LIST OF PRE-FILED HEARING EXHIBITS FOR GAREY REASONABLE USE EXCEPTION (2021-RUE-0001)

COMMUNITY DEVELOPMENT DEPARTMENT
STAFF REPORT
TO CITY OF LAKE FOREST PARK HEARING EXAMINER

Figure 1 Full size provided as an attachment

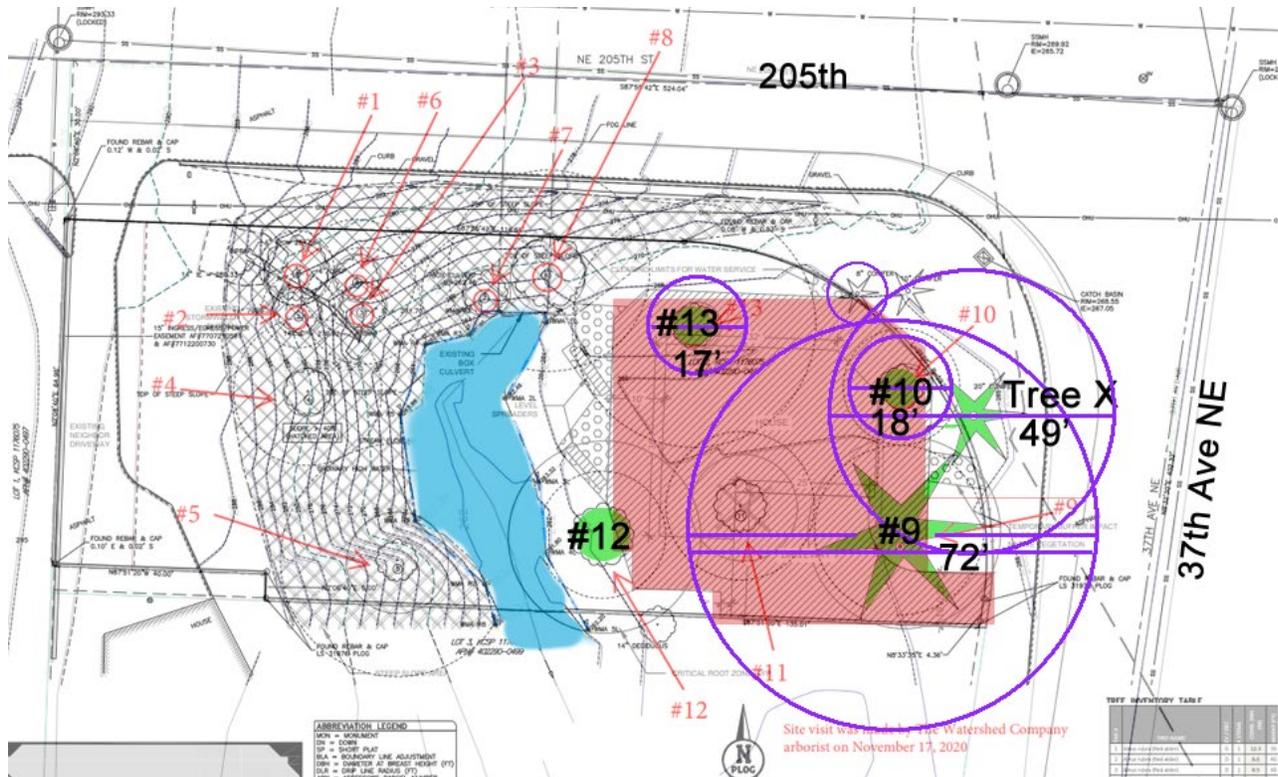
What will happen if trees go missing? Will anyone know? Are there any consequences for saying "only one tree will be removed" but somehow 4 other trees disappear?

Here is the list of inventoried trees on from the document. The ones I am questioning are the significant trees outlined in red and the evergreen that is nameless on the east border on 37th ave. Plus why aren't the other 22 trees on this map.

Figure 4 Parcel and adjacent parcels

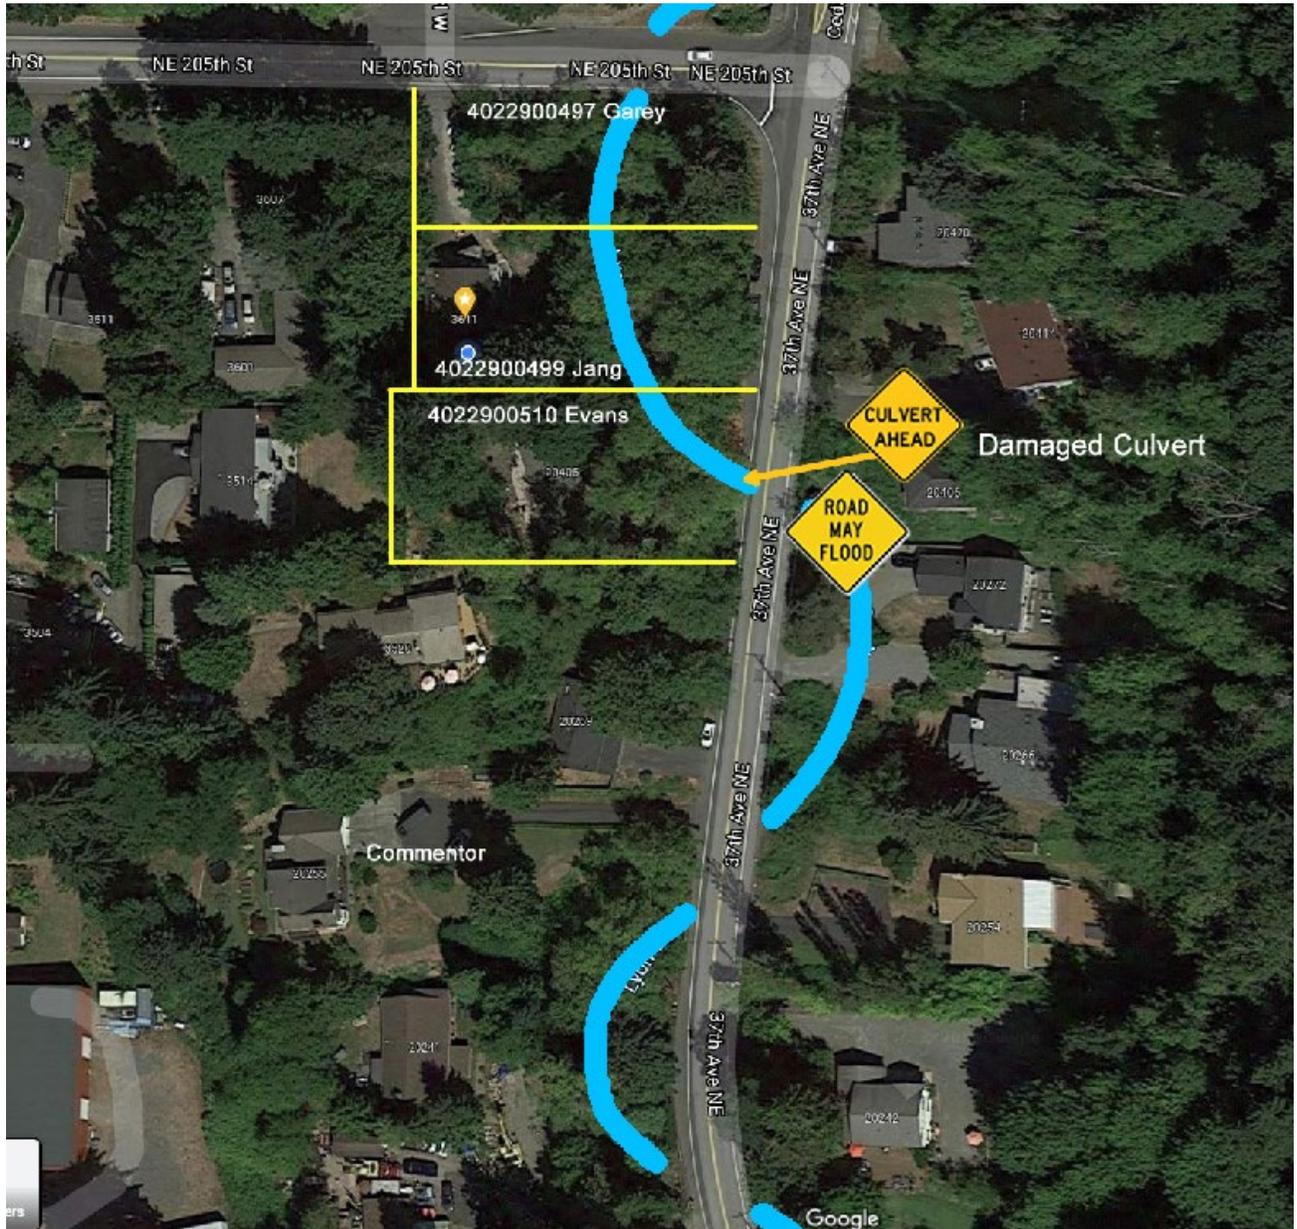
Garey’s proposal says "Avoidance: The project avoids direct impacts to Lyon Creek and there will be no less impact that can be done." If you believe it is true, **where is the evidence?**

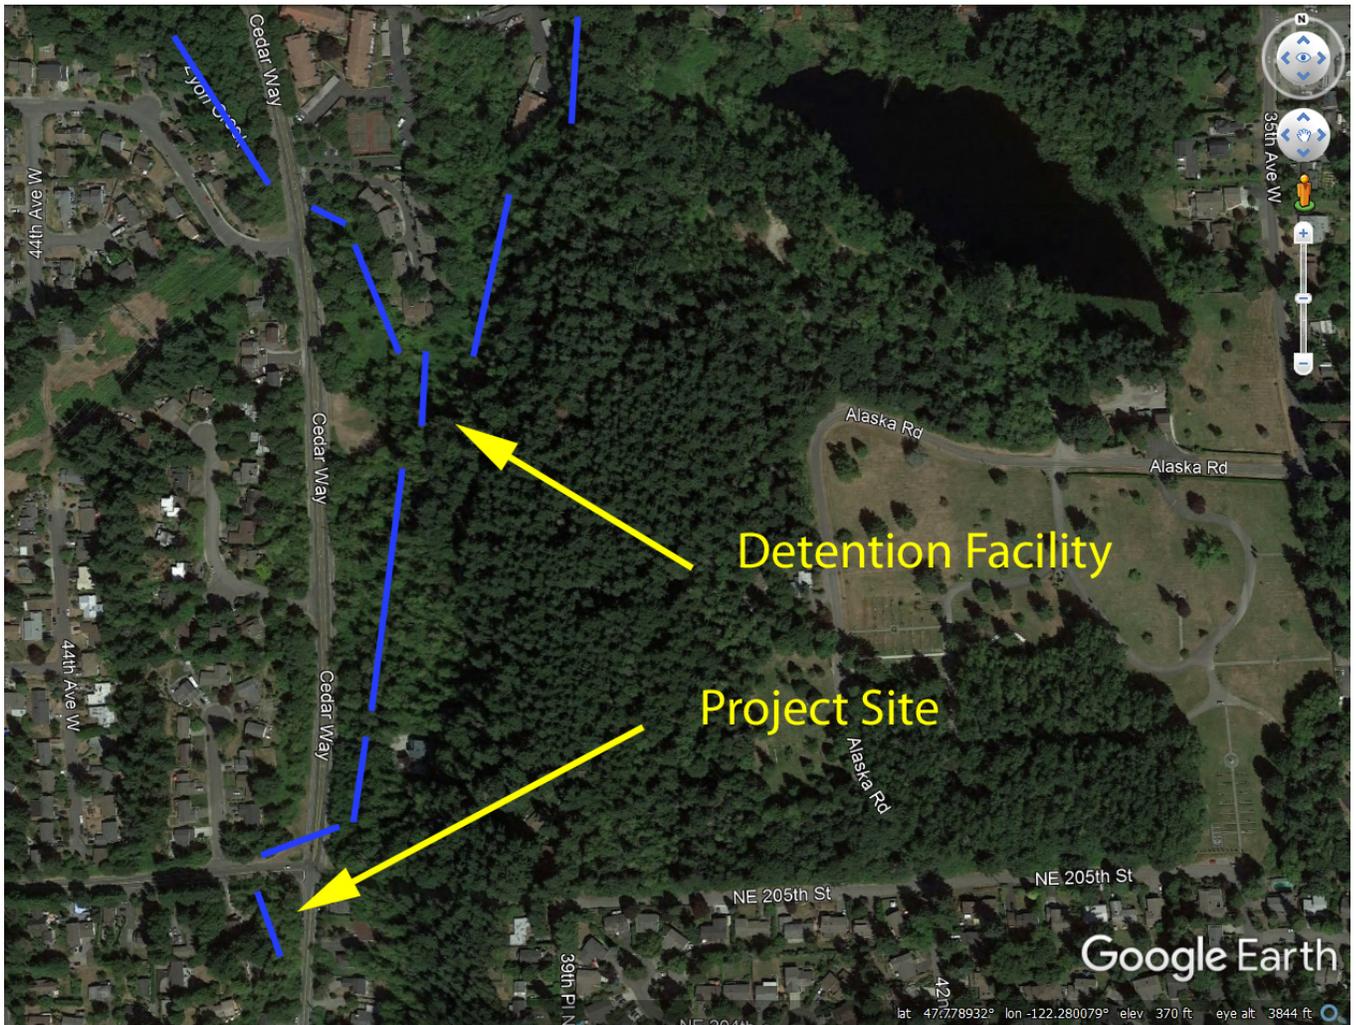
What about the upstream detention pond flooding?

The proposal report says there are no up or downstream issues. That is untrue.

Wrong. Here is proof.

Photo 3

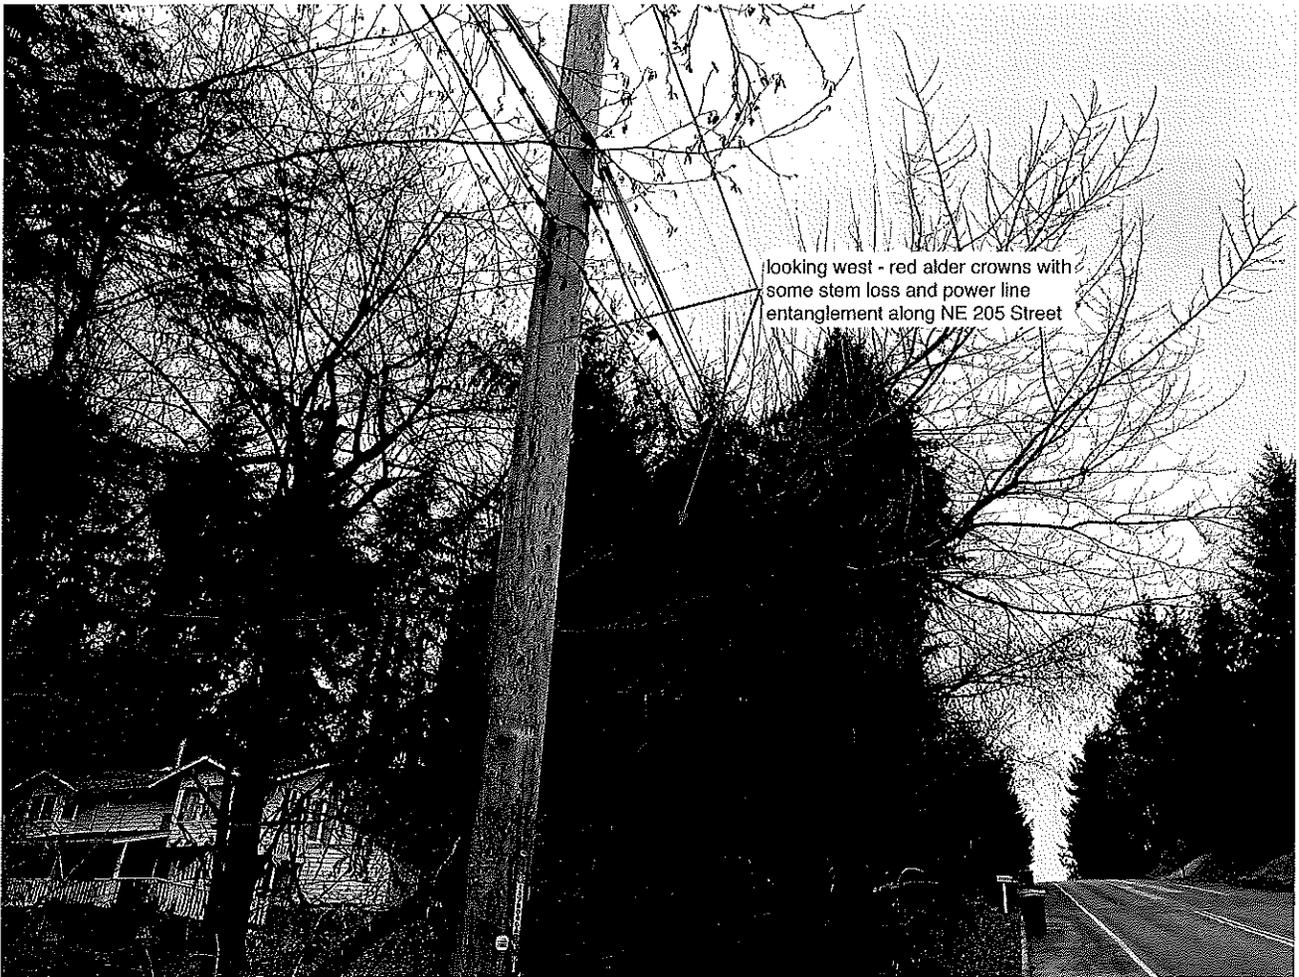
Development of this parcel would remove any meaningful buffer at this location for Lyon Creek and would further degrade the environmental services that the parcels in this reach provide. I observed that the culvert downstream of the property was showing the effects of recent storms, a process that will only be hastened by development of this property (Photo 3).
